Service Bulletin

Bulletin No.: 17-NA-221

Subject: Poor Engine Performance in Extremely Cold Weather Conditions for LE2 Engines, Charge Air Cooler Icing - Malfunction Indicator Lamp (MIL) Illuminated, DTC P0299, P0234, P0236, P2227, P00C7 Set

Brand:	Model:	Model Year:		VIN:		Engine:	Transmission:
		from	to	from	to		
Buick	Encore	2016	2022	—	—	1.4L (LE2)	—
Chevrolet	Trax	2021	2022

Grille Winter Cover Installation

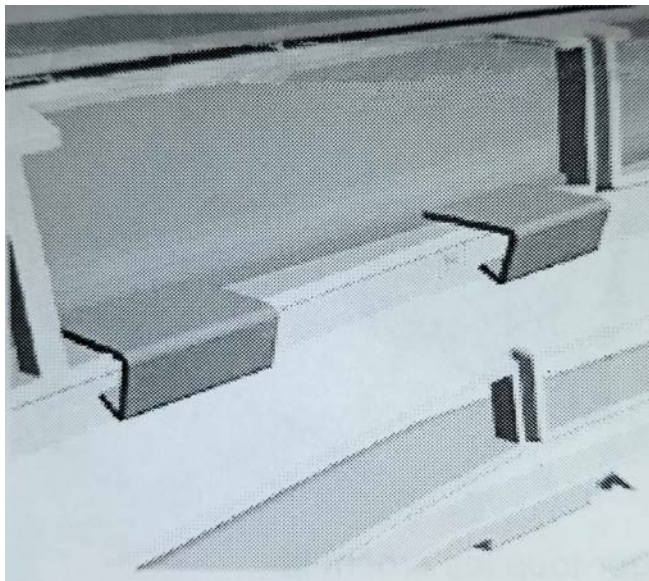
Warning: Remove grille cover during temperatures above 32°F/ 0°C to prevent engine and transmission overheating. Remove grille cover before towing a trailer of any size. Failure to do so will decrease transmission cooling efficiency and possibly cause damage to the drivetrain.

Note: The cover may appear to be undersized. The vinyl used may stretch during installation to ensure a tight fit. It is highly recommended that the cover be installed in a warm shop environment.

1. Using care, orientate the fascia winter cover to the bumper fascia.

2. Attach the cover to the fascia by pushing the hooks through the grille openings.
3. Validate that all the hooks are engaged and the cover is a tight fit.

Turbocharger Air Pressure Sensor Inspection

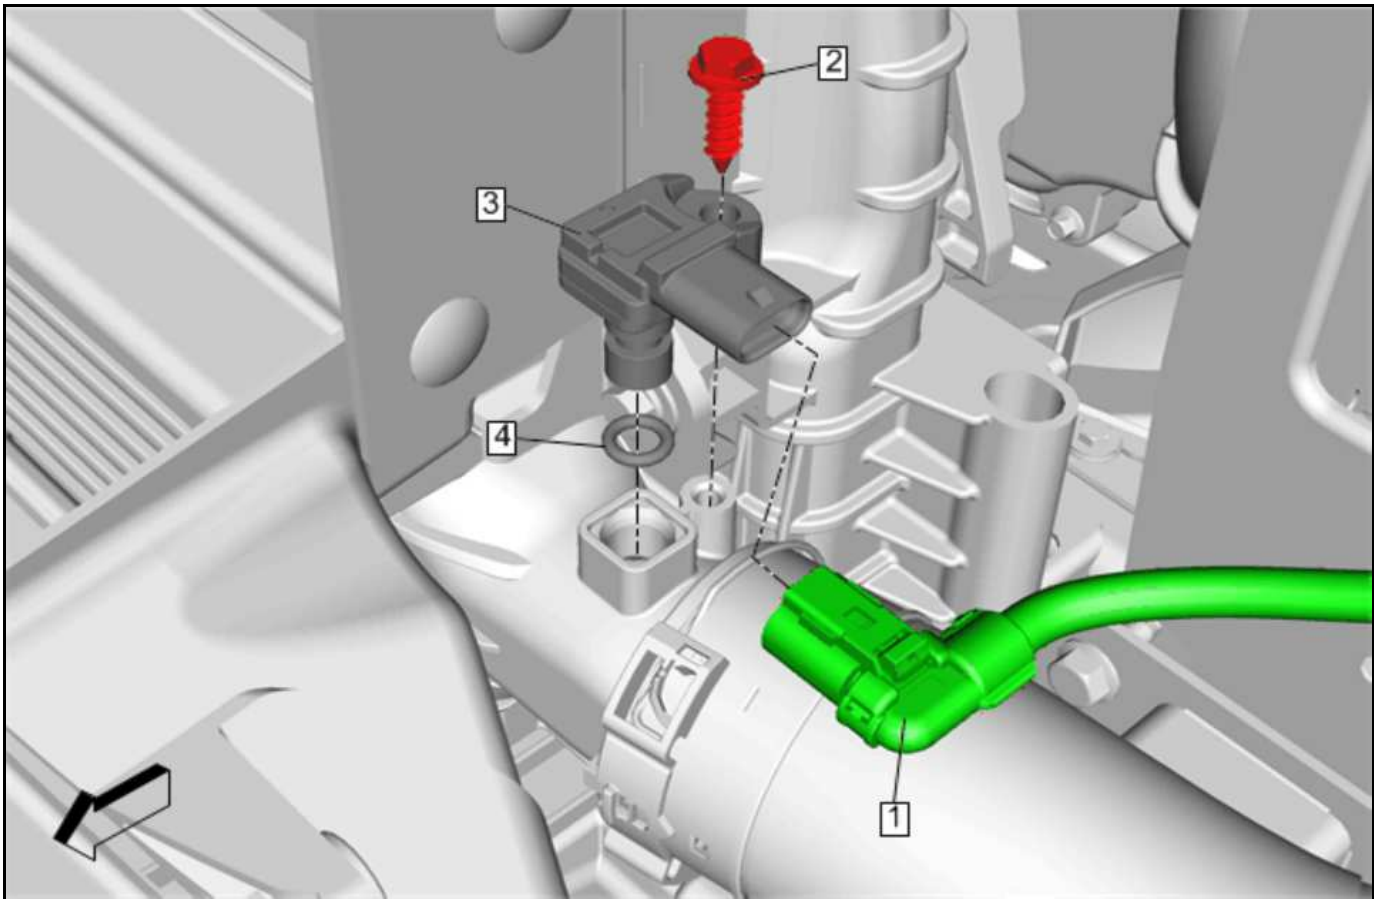
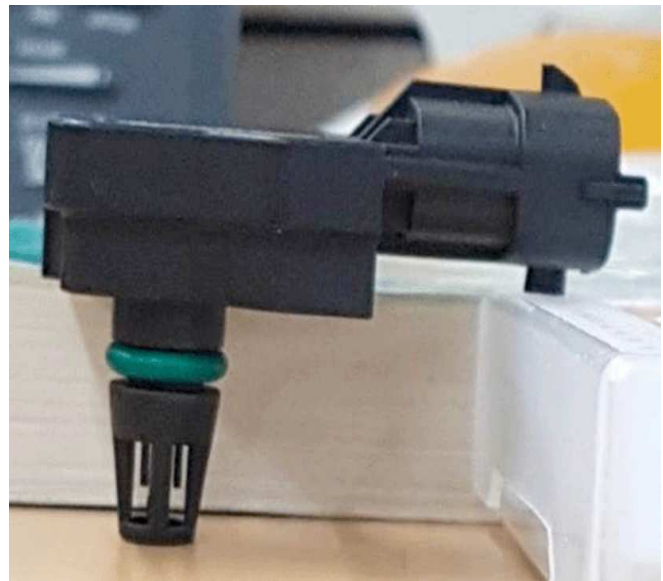
Important: Only perform steps 1-5 if DTC P0299 is set.

Important: Due to the sensitivity of the sensor, **Do Not** use any chemical cleaners including water and **Do Not** use compressed air to remove contaminants.

1. Remove the turbocharger Air Pressure sensor (3). Refer to *Turbocharger Air Pressure Sensor Replacement* in SI.

2. Inspect the sensor for any contaminants.

3. Allow time for any ice build-up to melt by placing the sensor port down.
4. Clean the sensor with a clean towel.
5. Install the sensor.

Service Procedure

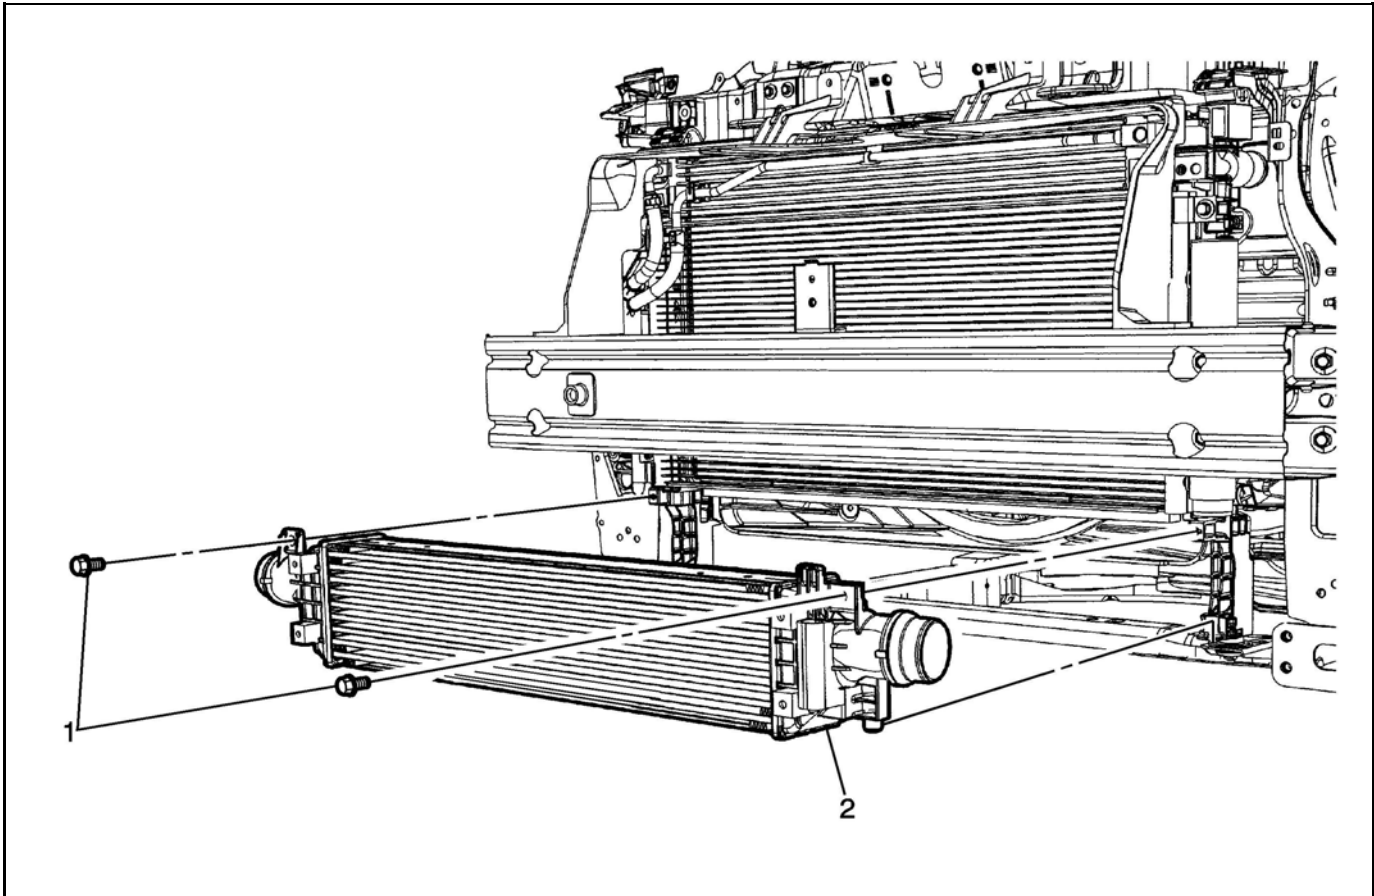
- If the oil change was recently done and no signs of moisture have been confirmed, Do Not proceed with procedure.
- If the oil change was not previously done or moisture has been found in the oil, proceed with procedure.

1. Install the CAC (2). Refer to *Charge Air Cooler Replacement* in SI.

2. If required, perform an oil change. Refer to *Engine Oil and Oil Filter Replacement* in SI.
